# UNITED STATES PATENT AND TRADEMARK OFFICE

| APPLICATION NO.   | FILING DATE | FIRST NAMED INVENTOR | ATTORNEY DOCKET NO. | CONFIRMATION NO. |
|---|-------------|----------------------|---------------------|------------------|
| 10/613,646  | 07/02/2003  | Burns Phillips       | 50243-0001          | 4622             |

| <b>Office Action Summary</b> | Application No.                | Applicant(s)     |

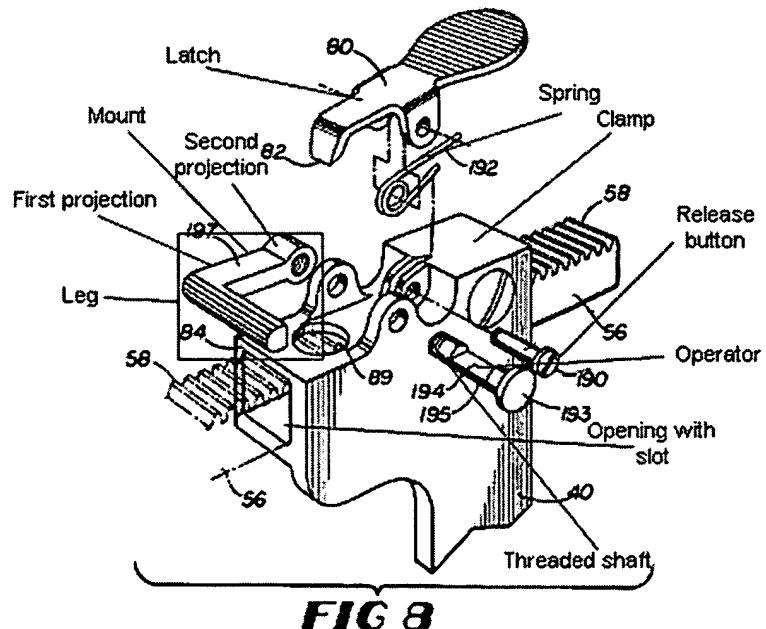
Claims 17-29 are rejected under 35 U.S.C. 102(b) as being anticipated by Furnish (U.S. Patent Number 5,788,630).

Furnish discloses various embodiments of a surgical retractor comprising a clamp having an opening with a slot having an upper and a lower surface, a latch is pivotally connected to the clamp, a spring biases the latch, a release button disengages the latch, an angularly adjustable leg is pivotally coupled to the clamp and extends cantileveredly away from the clamp (see figures 9 and 10), wherein the leg has a mount, wherein the mount has a first and a second projection, an operator is connected to the leg, wherein the operator has a threaded shaft and a release button, e.g. 193 in combination with 194 and 195 of figure 8 below), and the latch engages a tooth on the arm (see figures 9 and 10).
